# ERRATA

N° 10182AERRA

## Correction of RBSOA Characteristic in IFF450B12ME4P\_B11 and IFF450B12ME4S8P\_B11 data sheets

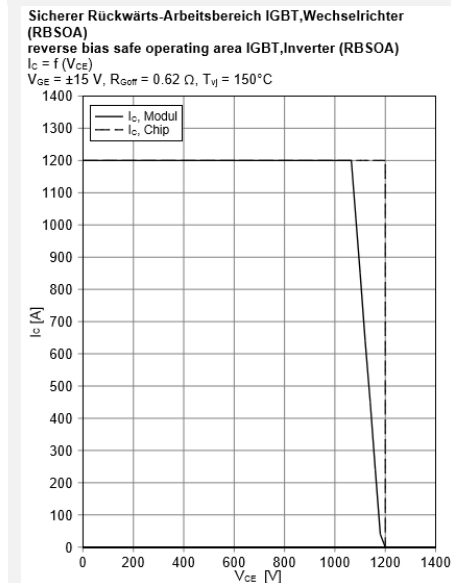
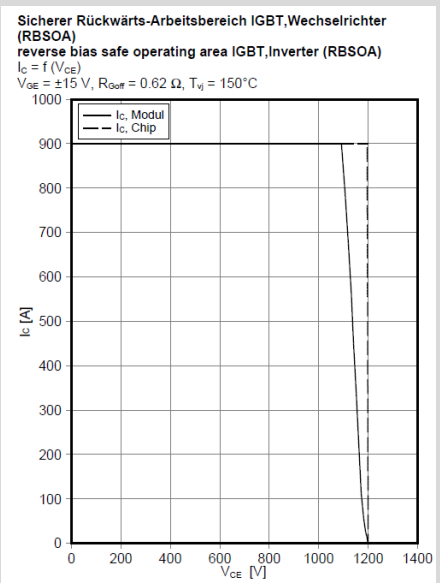
**Subject:** Due to wrong scaling RBSOA Characteristic curve of both IFF450B12ME4P\_B11 and IFF450B12ME4S8P\_B11 data sheets is incorrect

**Reason:** Manual entry error

Shift of RBSOA Characteristic curves
